Form 3160-3 (June 2015)					APPROVE 0. 1004-01 nuary 31.	37
UNITED STATES	-	1				
DEPARTMENT OF THE INT BUREAU OF LAND MANAG		5. Lease Serial No. NMNM17241				
APPLICATION FOR PERMIT TO DRII		6. If Indian, Allotee	or Tribe N	ame		
1a. Type of work: Image: DRILL REEN	NTER			7. If Unit or CA Agr	eement, N	ame and No.
1b. Type of Well: Vil Gas Well Other	-			8. Lease Name and V	Wall No	
Ic. Type of Completion: Hydraulic Fracturing Single	Multiple Zone		YUKON 20 FED CO		3]	
				740H

PECOS DISTRICT DRILLING CONDITIONS OF APPROVAL

OPERATOR'S NAME:	EOG RESOURCES INCORPORATED
WELL NAME & NO.:	YUKON 20 FED COM 740H
SURFACE HOLE FOOTAGE:	567'/N & 1855'/E
BOTTOM HOLE FOOTAGE	100'/S & 660'/E
LOCATION:	Section 20, T.24 S., R.34 E., NMPM
COUNTY:	Lea County, New Mexico

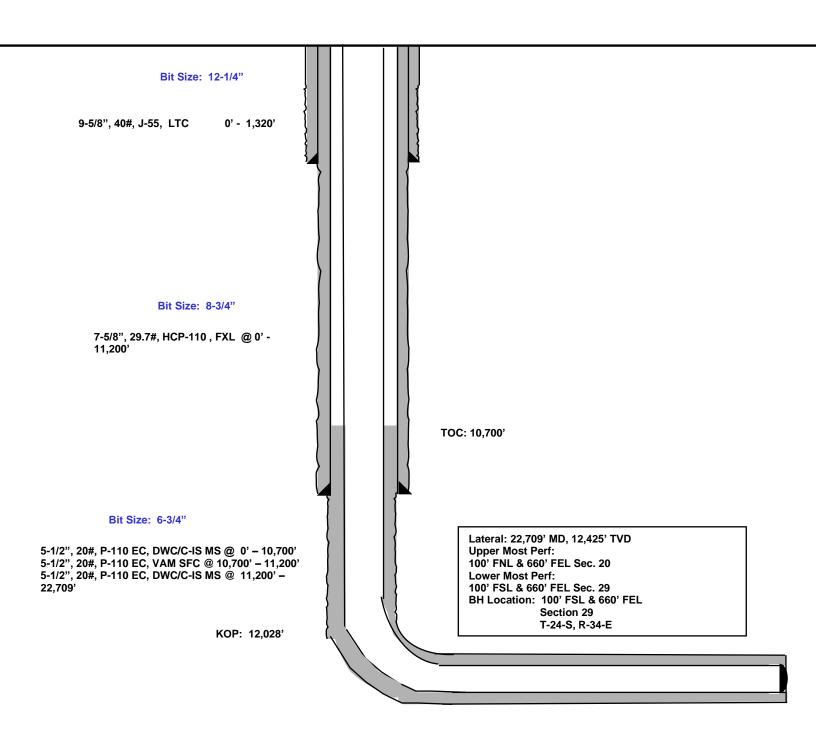
- a. Wellhead shall be installed by manufacturer's representatives, submit documentation with subsequent sundry.
 - b. If the welding is performed by a third party, the manufacturer's representative shall monitor the temperature to verify that it does not exceed the maximum temperature of the seal.

- b. If the welding is performed by a third party, the manufacturer's representative shall monitor the temperature to verify that it does not exceed the maximum temperature of the seal.
